HILLTOP ACRES SUBDIVISION

ENVIRONMENTAL REVIEW TEAM REPORT

ENVIRONMENTAL REVIEW TEAM REPORT
ON
HILLTOP ACRES
FRANKLIN, CONNECTICUT

Eastern Connecticut Environmental Review Team
Re: "Hilltop Acres Subdivision" - Franklin,
Connecticut
Date: October 15, 1985
Reviewer: Bill Warzecha, DEP Geologist

SURFICIAL GEOLOGY

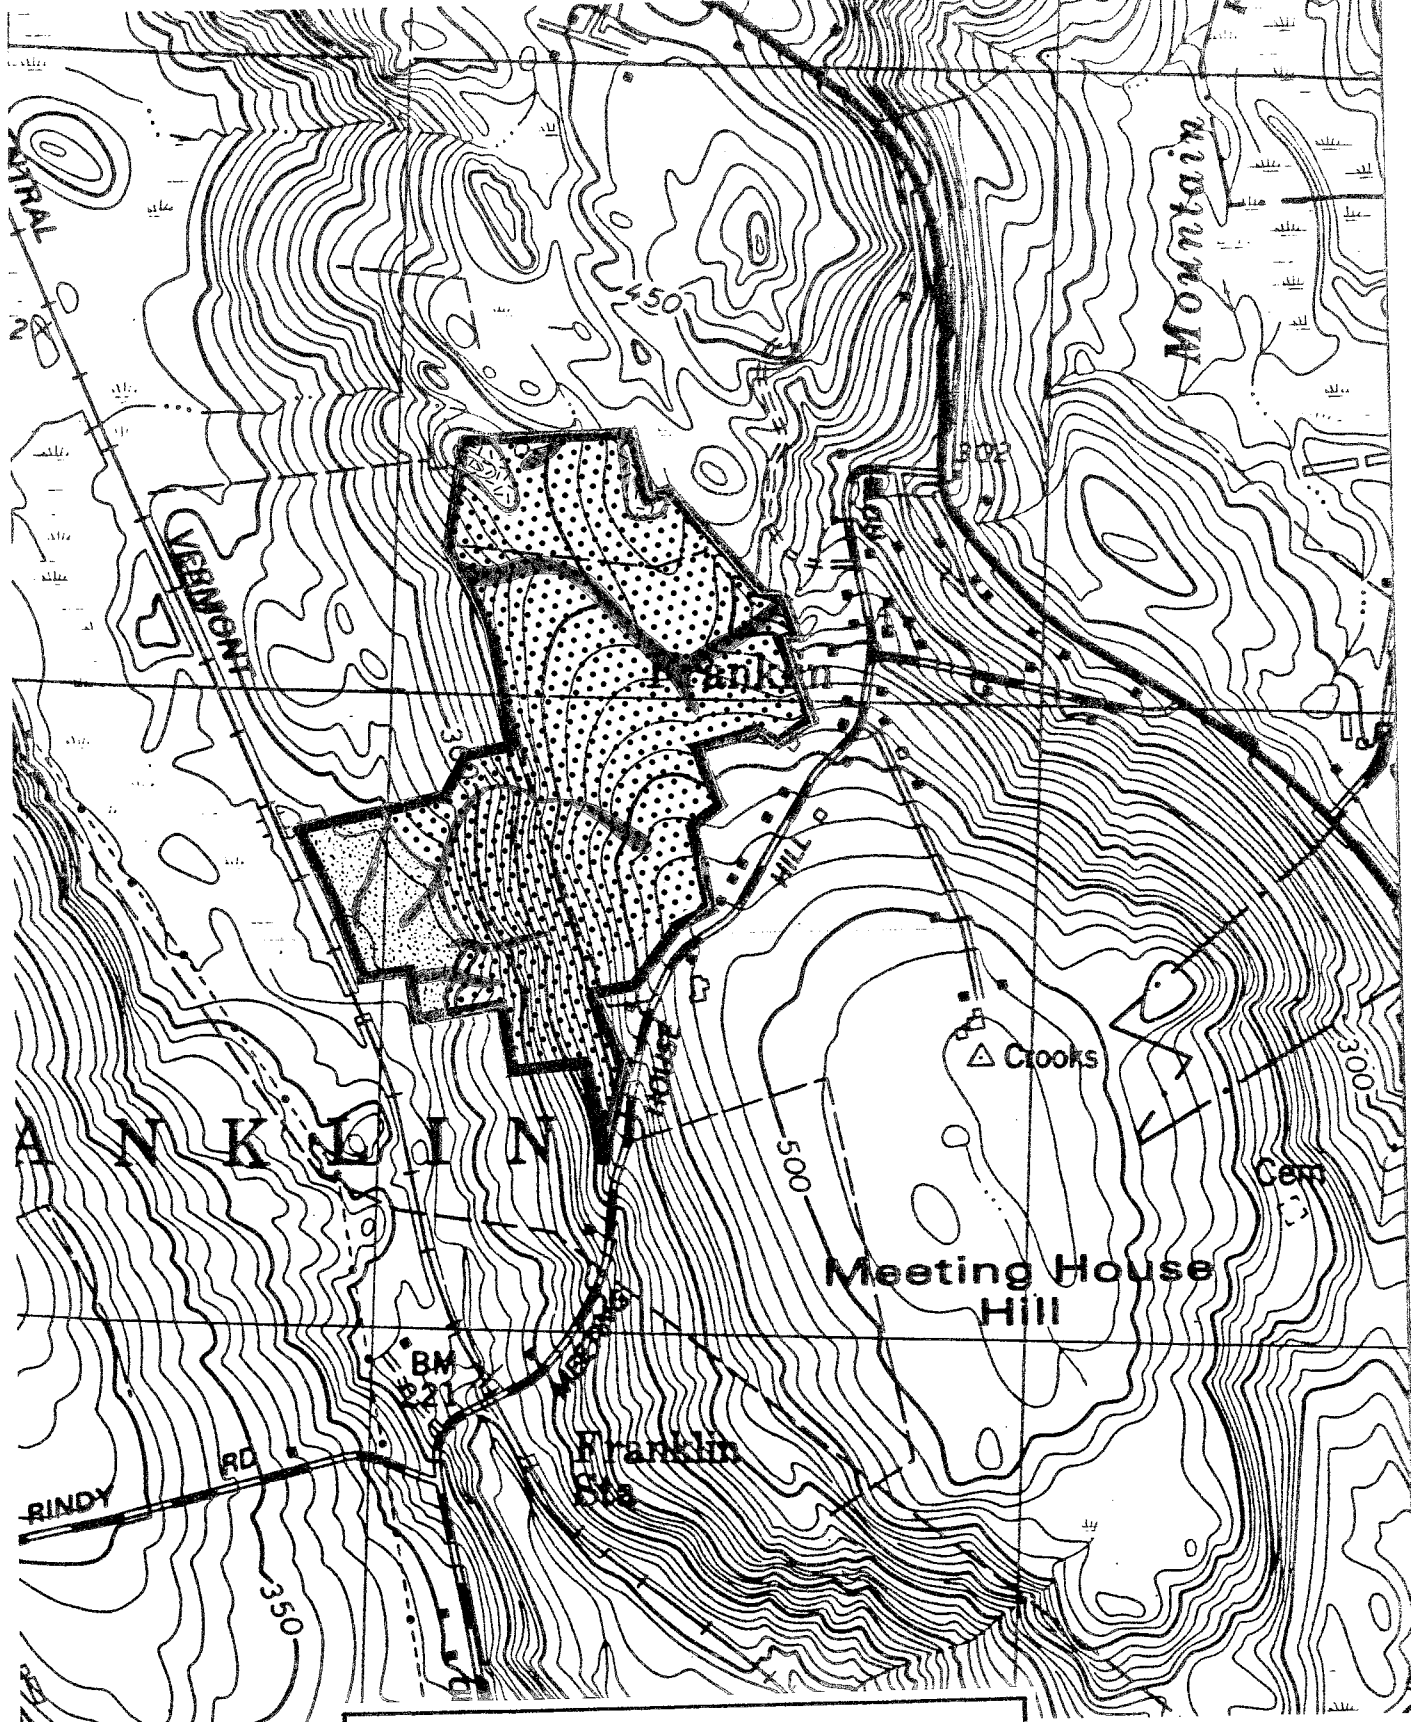
(Map GQ-485) indicates some shallow to bedrock areas at the northern limits of the property.

WATERSHED BOUNDARY

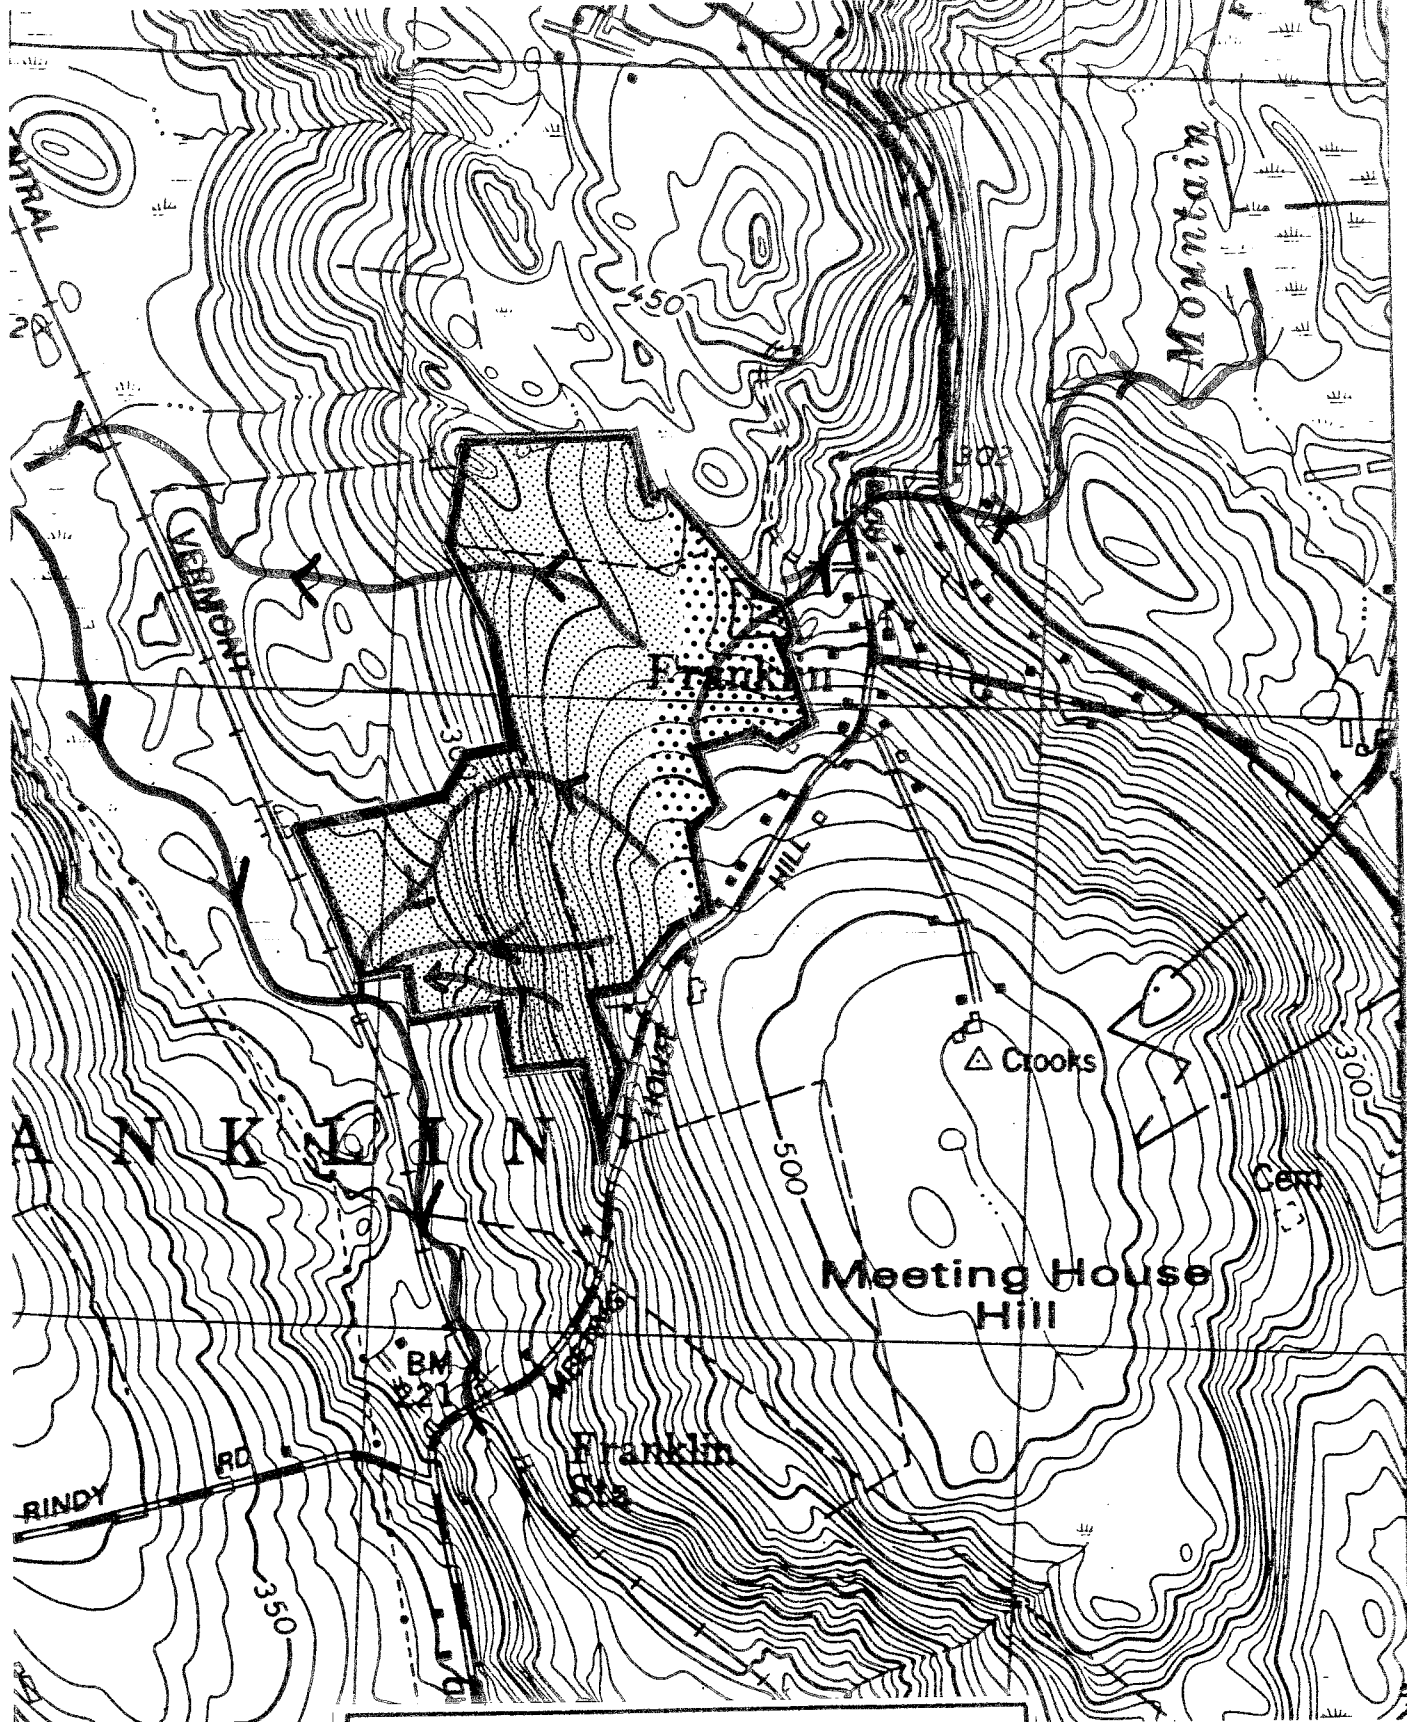
Most of the Crossen Property drains westward to Susquetonscut Brook, which is a tributary to Yantic River. Surface drainage in the eastern limits drains eastward to Mountain Brook. Mountain Brook ultimately drains into Mahoney Pond to the northeast. It appears that surface drainage from the proposed nine lot subdivision as well as possible future development on other lands owned by Crossen or on the Calabretta Property would drain mostly westward to Susquetonscut Brook.
